BULLETIN NUMBER:
SB18-C-001C

DOOR WIND NOISE/WATER INTRUSION – IMPROVED DOOR SEAL AND ADJUSTMENT PROCEDURE

This bulletin is being revised to update affected model years, parts, and procedures and supersedes bulletin SB18-C-001B. Please discard bulletin SB18-C-001B.

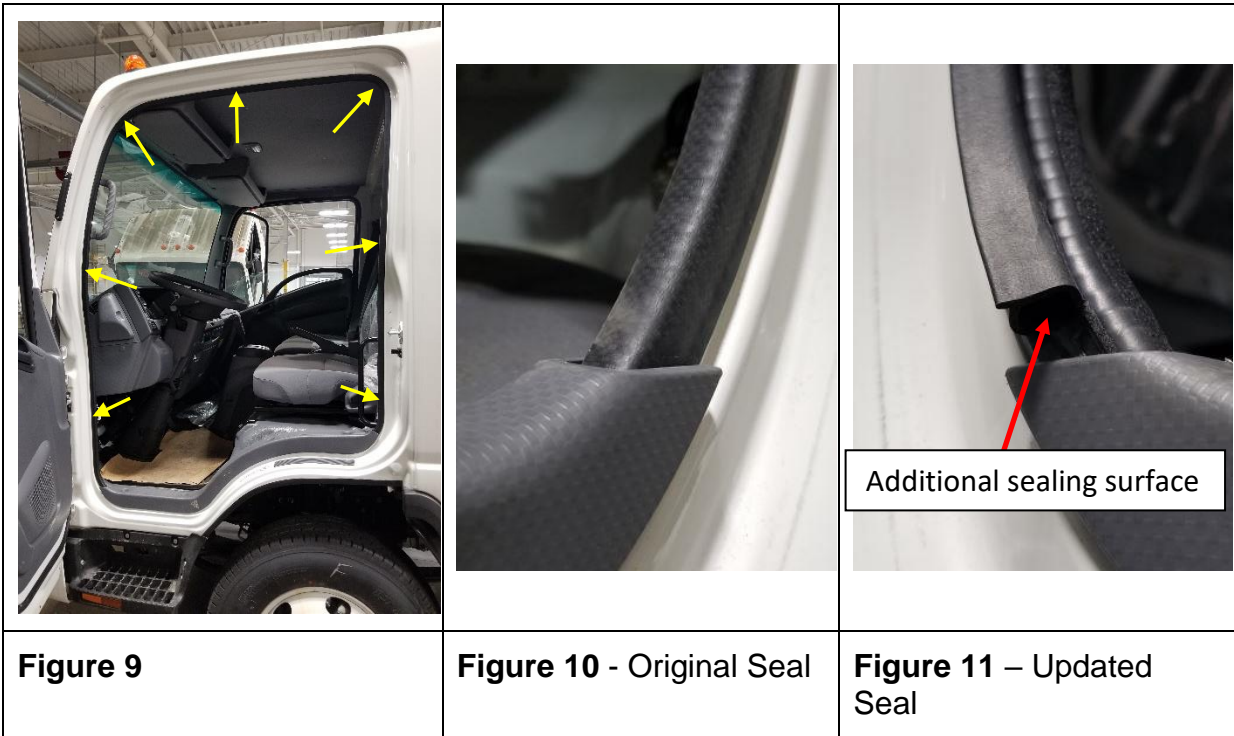
10. On single cab, N-Series vehicles and FTR vehicles check the seal on the **cab side** of the door opening (See Figure 9) to determine if it is an original seal design or a previously offered revision. (See Figures 10 & 11.)
- If the original seals are present as shown in Figure 10, replace them with the redesigned **cab seal** and continue to Step 11.
 - If the seals on the vehicle's **cab** are as those shown in Figure 11 skip to Step 24.
 - If vehicle is an N-Series crew cab continue to Step 11.

<p>Figure 20 - Original Seal</p>	<p>Figure 21 - Updated Seal – location of plastic pin stopper</p>	<p>Figure 22 –plastic pin stopper</p>

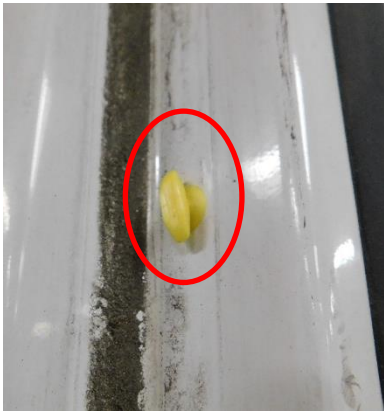
24. On single cab, N-Series vehicles check the seal on the **door side** of the door opening (See Figure 20) to determine if it is an original seal design or a previously offered revision.

- If the original seals are present as shown in Figure 20, continue to Step 25.
- If the seals on the vehicle's **door** are as those shown in Figures 21 & 22, skip to Step 28.
- If vehicle is an N-Series crew cab or FTR vehicle continue to Step 25.
